SCALE	NOTED
HEAT TREAT	NOTED
FINISH	ZP-AP
NAME	BELTFRAME-HULL STA. # 6.4
DWG.	J 28B5640

CONSOLIDATED AIRCRAFT CORP.

28B5640 B

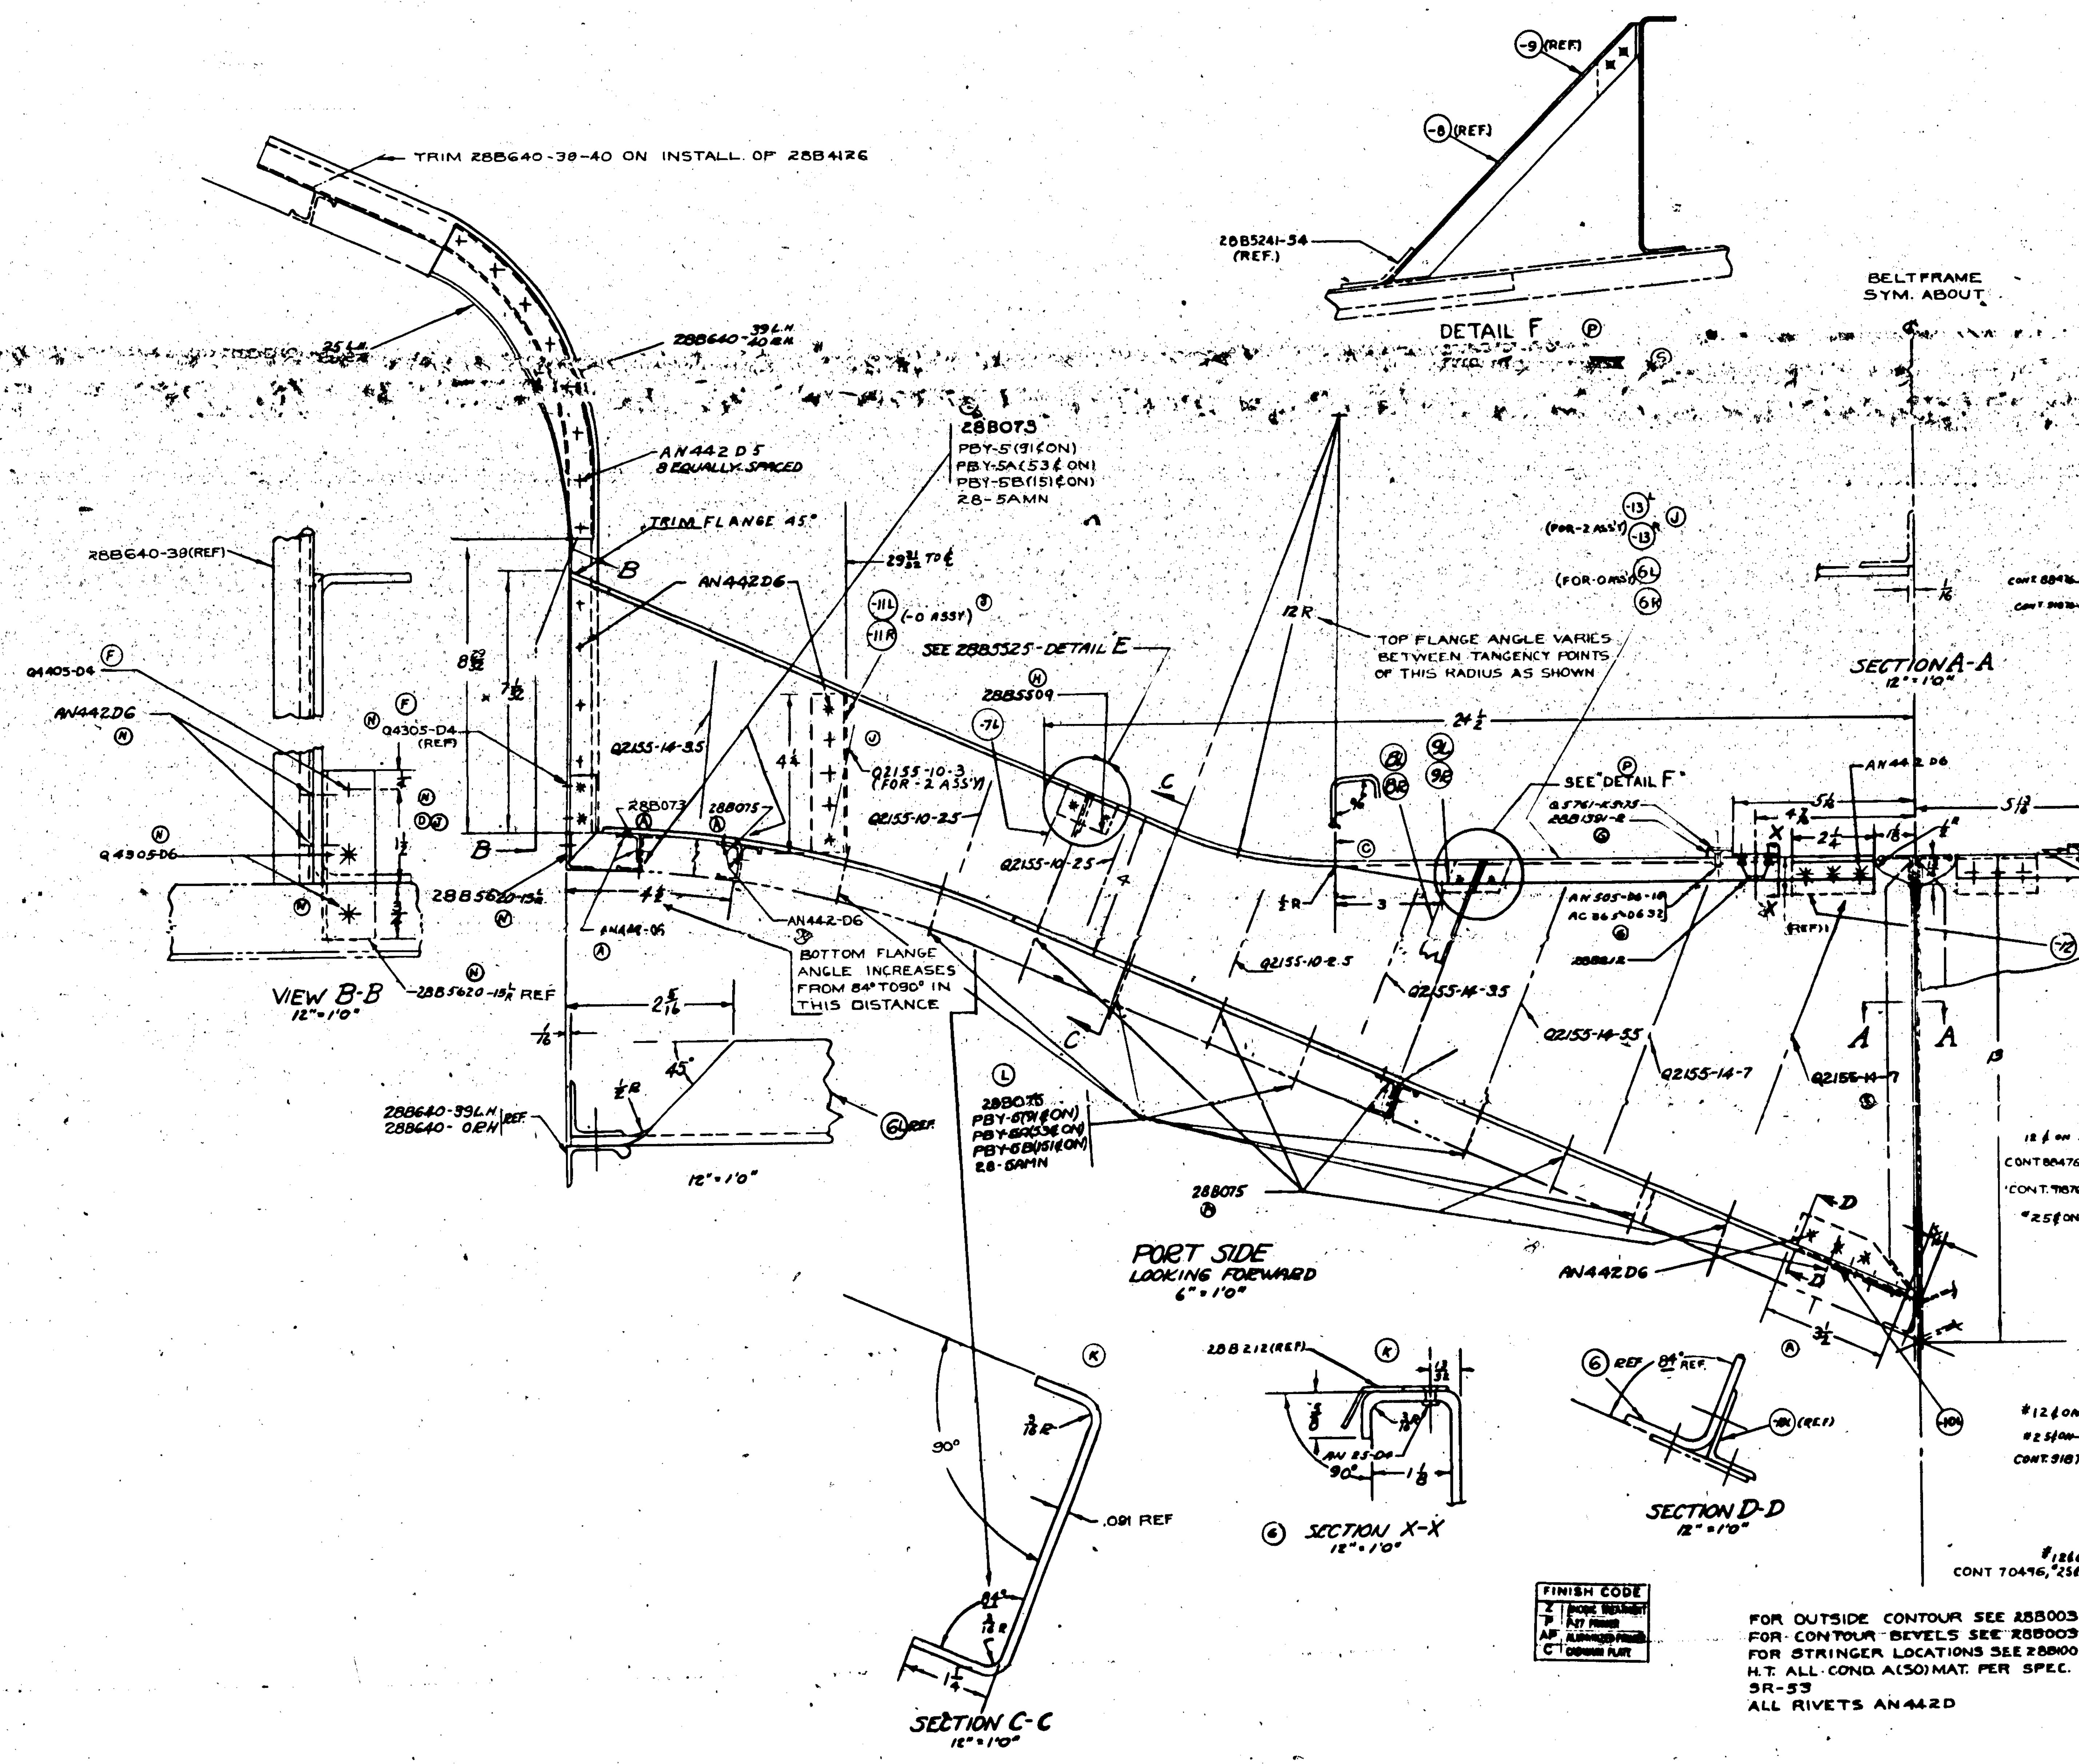
E.O.	LET	ALTERATION	DATE	BY
E.O. A39642	L	INDICATES CENTERLINES OF NEW INTERMEDIATE STRINGERS IN [illegible] [illegible] WAS [illegible] [illegible] WAS 28B077 (12) WT. CHG. [illegible]	[illegible]	[illegible]
E.O. A32275	M	IN B/M PBY-5 (41 ¢ ON) PBY-5A (53 ¢ ON) [illegible] 28B073 (2) WAS (4) 28B073 [illegible] NO WT. CHG.	[illegible]	[illegible]
E.O. A57188	N	Q4305-D4 WAS Q4303-D4. "G.S.'E ON -13 SIDE" REMOVED 28B5620-13. 28B5620-15 L.R. WAS 28B5620-7. Q4305-D6 (1) WAS AN442-D6 (1) WT. CHG. NEG.	[illegible]	[illegible]
E.O. B5874	P	REMOVED NOTE "SEE 28B5525 DETAIL E", REPLACED WITH "SEE DETAIL F", ADDED DETAIL F. CHG'D STOCK SIZE OF -8 FROM K5401X10 [illegible] TO K5401X9 [illegible] IN B/M. WT. CHG. NEG.	[illegible]	[illegible]
E.O. B18177	Q	IN B/M -7 L.R. Y2-A27RTX7 WAS -7 [illegible] K5401X7, -8 L.R. Y2-A27RTX10 [illegible] WAS -8 [illegible] K5401X10 [illegible]. NEG. WT. CHG.	[illegible]	[illegible]

R	AC365-D632, AN505 D6-10, Q5761-K5-1.5, Q5761-K5-.75, IN THE L.H. COLUMN OF -2 ASS'Y. WERE SHOWN IN THE R.H. COLUMN OF -0 ASS'Y. NO. WT. CHG.	7-19-45	[illegible]
E.O. B26396	S	CHG'D DIRECTION OF ARROW AT DETAIL "F" NO WT. CHG.	10/15/45	MORRIS

LET	ALTERATION	DATE	BY	E.O.
A	ADDED CLIP 28B073 TO STRINGER NEAR CHINE, CLIP 28B075 TO OTHER STRINGERS, CLIPS ADDED TO B/M, 3½ DIMENSION ADDED TO -10 AS PER E.O. 15751	[illegible]	[illegible]	
B	-2 ASS'Y ADDED, -11 L.R. ADDED. Q2155-10-3 ADDED. E.O. 21260A LIP REMOVED FROM UPPER FLANGE	[illegible]	[illegible]	E.O. 227 PBY 28-51
C	ADDED -13 L.R. (1), AN425 D4, Q4303-D6 AS PER E.O. 25076A	[illegible]	[illegible]	
E	Q2155-14-7 WAS Q2155-14-8 BROUGHT REF. PLANE UP TO DWG. NO WT. CHG.			
F	CHANGED AN425-D4 TO Q4303-D4 NO WT. CHG.	10-29-41	[illegible]	W.O. FLOYD 12-28
G	ADDED 28B212, 28B1391, 28B1391-2, Q5761-K5-1.5 & .75, AN505-D6-10, AN365-D632, AND SECTION X-X. WT. CHG. NEG.	[illegible]	[illegible]	E.O. 229
H	28B5509 WAS 28B5525-11 NO WT. CHG.	6-2-42	[illegible]	E.O. 22348
J	ON FACE 28B5620-13 WAS -11. ADDED -13 L&R, CALL OUT TO FACE IN B/M, MAT'L .051X4 3/4X15 24SO 47AB-A WAS .072X3/4X1 1/2 24ST 47AB-T. Q2155-10-3 REPLACED L&R FOR -2 ASS'Y. NO WT. CHG.	4-2-42	[illegible]	E.O. A29371

K	REMOVED LIP FROM UPPER FLANGE. SECTION C-C ADDED. ⅛, 3/16 R 90° DIMS. TO SECT. X-X (NO WT. CHG.)	4-24-[illegible]	[illegible]
